In re Application of:)
: Examiner: W. Royer
NORIIHIKO KUBO)
: Group Art Unit: 2852
Application No.: 10/068,842)
:
Filed: February 11, 2002)
:
For: CLEANING APPARATUS) December 1, 2003
INCLUDING A TONER BREAKING :
MEMBER AND IMAGE FORMING)
APPARATUS USING SAME :

REQUEST TO MAKE DRAWING CHANGES

FIG.1

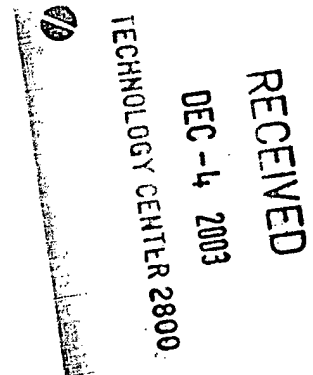
Enclosed are copies of proposed drawings changes shown in red ink to Figure 1.

These changes consists of adding arrows denoting a rotation direction of the photosensitive drum 3a and the transfer belt 130, reinserting reference numeral 7 to depict a pair of registration rollers, and redirecting the lead line of reference numeral 12 to depict a conveying guide. In addition, numeral 1s has been replaced with 13.

A replacement sheet of Figure 1 is being prepared to incorporate these changes and will be submitted as soon as possible.
